Applicant:	Kraus-Anderson Inc. (owner)
Location:	7803 Penn Avenue
Request:	<ol style="list-style-type: none">1) Preliminary development plans for a partial redevelopment of the Southtown Shopping Center located at 7803 Penn Avenue S. to accommodate an approximately 120,000 square foot retail store and a future medical office building development phase;2) Final development plans for an approximately 120,000 square foot retail store at 7803 Penn Avenue S. along with site modifications;3) Preliminary plat to subdivide 7803 Penn Avenue S. into four lots to accommodate existing and proposed development; and4) Platting variance to defer park dedication on future development phases until building permit issuance for that development phase.
Existing Land Use and Zoning:	Retail shopping; zoned C-3(PD) and C-5(PD)
Surrounding Land Use and Zoning:	North – Interstate 494 South – Mixed-Use and restaurants; zoned C-5 and C-5(PD) East – Hospitality and a vacant auto dealership; zoned C-4 West – Retail, restaurants, financial services; zoned CR(PD)

PROPOSAL

Case PL202400102

Project Description: Major Revision to Preliminary and Final Development Plans for a partial redevelopment of the Southtow

Figure 1: Future Southtown Development Intensity

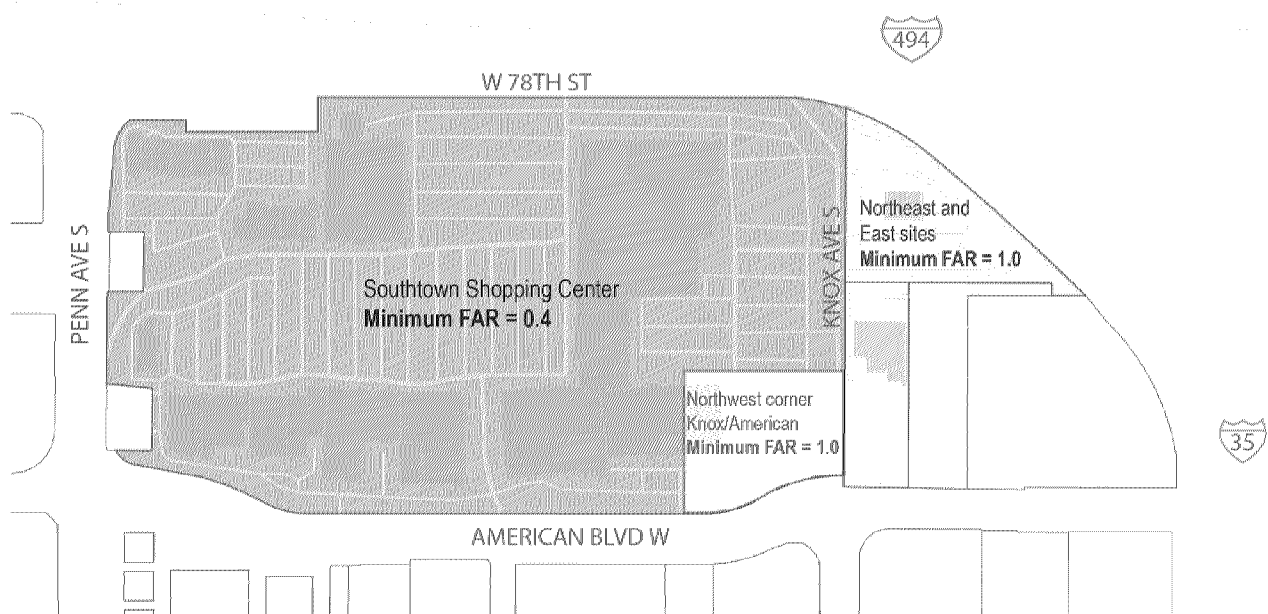
With a significant caveat, staff is supportive of the proposed PDP as it meets the desire of the applicant to bring in Dick’s House of Sport now, but sets the stage for additional future development. The proposed FAR for the main shopping center, identified as “Southtown Shopping Center” in Figure 1, will be approximately 0.37 after completion of the Dick’s and medical office phases. This FAR is 7.5 percent less than the 0.4 requirement established in the existing development agreement.

No future development phase is proposed in the Northwest corner Knox/American sub-area, which is zoned C-5. The minimum FAR in this area is 1.0. While no development is proposed now, intensive development that meets the minimum FAR is critical to implementing the vision established in the Penn American District Plan. Knox and American is a highly visible corner directly adjacent to a BRT station and warrants dense development. While not officially proposed as part of this application, the applicant included a conceptual development that could be implemented on the site. This conceptual phase consists of a six-story, 250-unit mixed use building with an FAR of 1.15. Sanitary sewer capacity is a concern in this area and the City is diligently studying

alternative funding scenarios to meet future sewer demand and allow future growth. While staff is supportive of the proposed preliminary development plan, staff does not support eliminating the minimum 1.0 FAR requirement in the Northwest corner Knox/American sub-area as memorialized in existing development agreements with the applicant.

A third sub-area, “Northeast and East sites,” is not included in the proposed preliminary development plan. This area is also critical in implementing the Penn American District Plan but is being treated as an independent site from Southtown Shopping Center. The applicant had submitted a massing graphic depicting two additional development phases in the Northeast and East sites, although those phases are purely conceptual. Nonetheless, it depicts the dense, pedestrian-friendly, and transit supporting development envisioned in the Penn American District Plan.

1. Ongoing Planned development flexibility regarding floor area ratio is not granted to the portion of the planned development zoned C-5. Future development on the C-5 portion of the planned development must meet a 1.0 minimum floor area ratio standard unless otherwise compliant with the Bloomington City Code or flexibility is granted through the Planned Development process.
